Subject: Class II permissive change Request  
FCC ID: AMUMM300

Granted on: 06/15/2023

Pursuant to CRF Section 2.1043, SCR engineers LTD requests a Class II permissive change to update the filing. All of the changes are not effect to the RF performance, function and power.

Transmitter  
CS

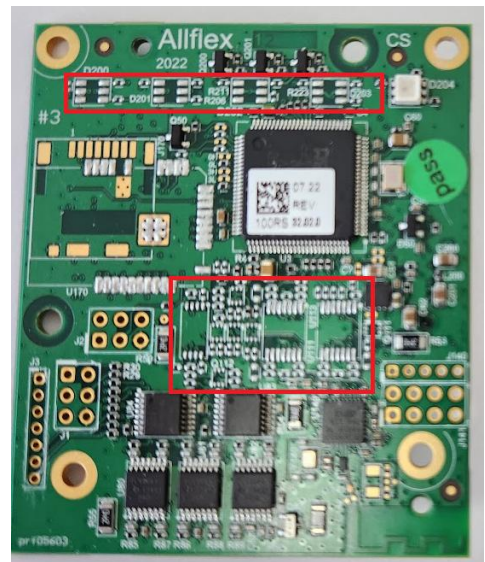
1. Remove temperature sensor (thermopile) and MCU support component.
2. Remove RGB detector and MCU support component.
3. Remove white led MCU support component.
4. Reduce multi color led indicators from five to one MCU support component.
5. Change model number.

You must provide a comparison between the old and new photos and circle the differences  
Picture
